UNITED STATES PATENT AND TRADEMARK OFFICE

APPLICATION NO.	FILING DATE	FIRST NAMED INVENTOR	ATTORNEY DOCKET NO.	CONFIRMATION NO.
10/674,354	10/01/2003	Nobuhiro Inoue	243412US3	3815
22850	7590	10/05/2007	EXAMINER	
OBLON, SPIVAK, MCCLELLAND MAIER & NEUSTADT, P.C.			LAZORCIK, JASON L	
1940 DUKE STREET			ART UNIT	PAPER NUMBER
ALEXANDRIA, VA 22314			1731	
NOTIFICATION DATE		DELIVERY MODE		
10/05/2007		ELECTRONIC

Office Action Summary	Application No.	Applicant(s)	
	10/674,354	INOUE ET AL.	
	Examiner	Art Unit	
	Jason L. Lazorcik	1731

DETAILED ACTION

FIG. 6A

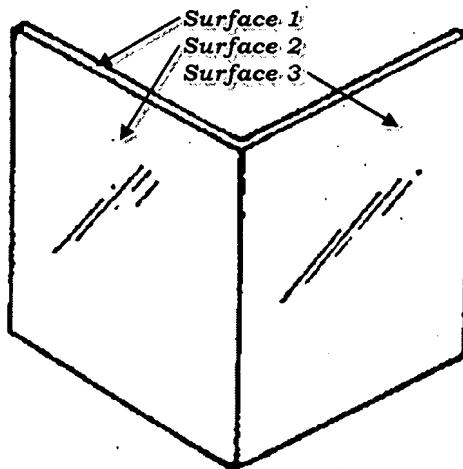
The reference also sets forth that "a radius of curvature of the outer circumference of the bend transverse to the bend in the shaped glass sheet thus produced was 5mm, i.e. 1.2 times the thickness of the glass sheet in the straight sections" (column 14, Lines 24-27). The immediate disclosure reads directly upon claim 2 wherein the bent glass sheet includes a portion having a radius of curvature of not larger than 100mm. Further as clearly depicted in figure 6a, Tomozane teaches a glass sheet which includes a corner where three surfaces connect together and each surface is a flat surface.
